Work Order ID 107775

Item Name: Crosstube Turning Detail

DART AEROSPACE LTD	Work Order:	107775
Description: Crosstube Assembly	Part Number:	D407-667-145
Inspection Dwg: D407-667-145 Rev: C		Page 1 of 2

DRAWING NO. D407-667-145	TITLE CROSSTUBE ASS'Y (407 HIGH FWD)	REV. C	DART AEROSPACE LTD ENGINEERING ORDER		D.E.O. NO. D407-667-145-C-1	SHEET NO. SHEET 1 OF 1	SCALE NTS
DRAWN 9	CHECKED 155	MFG. APPR. 155	APPROVED WD		DE APPR. H		
DATE 11.07.15	DATE 11.07.22	DATE 11.07.22	DATE 11/07/22		DATE 11.07.21

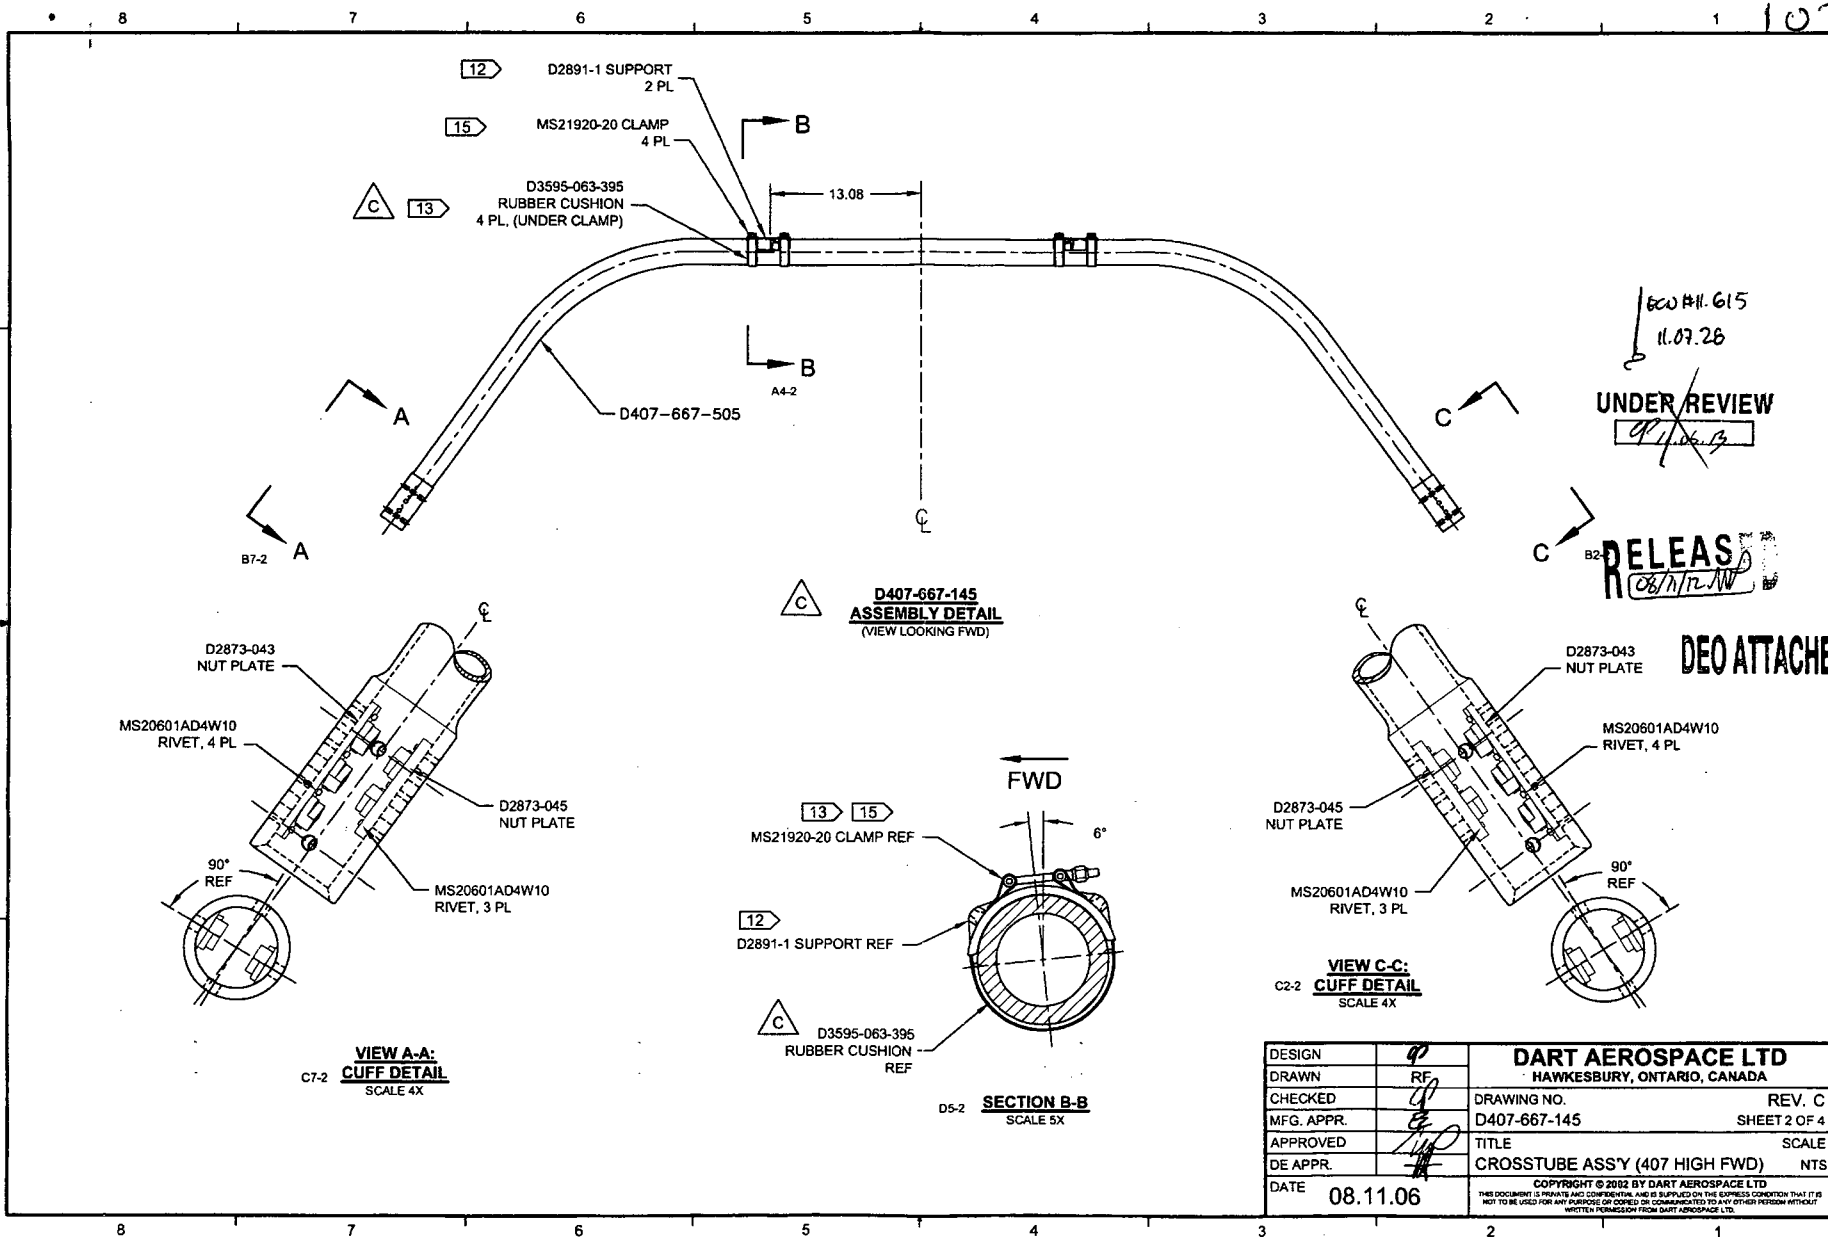
C	REVISE GENERAL NOTES/PART LIST (ZN D7-1); REORGANIZED VIEWS AND REFORMATTED DRAWING TO CURRENT STANDARDS. D3595-063-395 WAS D2856-400-694 (ZN D6-2 & A5-2); REMOVED REF. 7 ADD TOLERANCES (ZN C6-3, C4-3, D2-3); RELOCATED FLAG #6 (ZN A8-3) PER NCR 210; MOVED TURNING DETAIL & UPDATED TOLERANCE TO SHEET 4.	RF	08.11.08
B	ADD HOLES AND NUT PLATES FOR COMPATABILITY WITH BHT/AA SKUDTUBES	PH	05.07.26
A	NEW ISSUE	CP	02.05.08
REV.	DESCRIPTION	BY	DATE
DESIGN	RF	DART AEROSPACE LTD HAWKESBURY, ONTARIO, CANADA	
DRAWN	RF	DRAWING NO.	REV. C
CHECKED	RF	D407-667-145	SHEET 1 OF 4
MFG. APPR.	RF	TITLE	SCALE
APPROVED	RF	CROSSTUBE ASS'Y (407 HIGH FWD)	NTS
DE APPR.	RF	COPYRIGHT © 2002 BY DART AEROSPACE LTD THIS DOCUMENT IS PRIVATE AND CONFIDENTIAL AND IS SUPPLIED ON THE EXPRESS CONDITION THAT IT IS NOT TO BE USED FOR ANY PURPOSE OR COPIED OR COMMUNICATED TO ANY OTHER PERSON WITHOUT WRITTEN PERMISSION FROM DART AEROSPACE LTD.

DETAIL P
BONDING STRAP INSTALLATION 2 PL

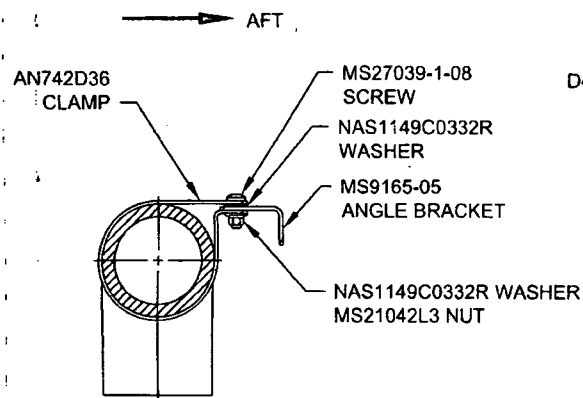
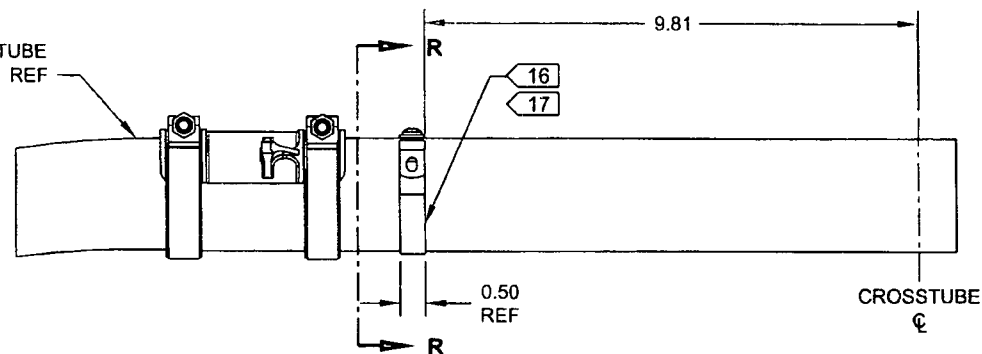
ADD ELECTRICAL GROUNDING STRAP

ITEM	QTY -145	PART NUMBER	DESCRIPTION
1	X	D407-667-145	CROSSTUBE ASSEMBLY (407 HIGH FWD)
10	2	AN742D36	CLAMP
11	2	MS9165-05	ANGLE BRACKET
12	2	MS21042L3	NUT (OR MS21042-3)
13	2	MS27039-1-08	SCREW
14	4	NAS1149C0332R	WASHER (OR AN960C10L)

- 16) MASK AREA UNDER CLAMP PRIOR TO PAINTING
- 17) SEAL EDGES WHERE AN742D36 CLAMP MEETS WITH THE CROSSTUBE USING SIKAFLEX-241/-291 OR MIL-S-8802 CLASS B2 OR PROSEAL 890 SEALANT
- 18) PERFORM RESISTANCE CHECK TO ENSURE MAX RESISTANCE IS 10 MILLIOHMS
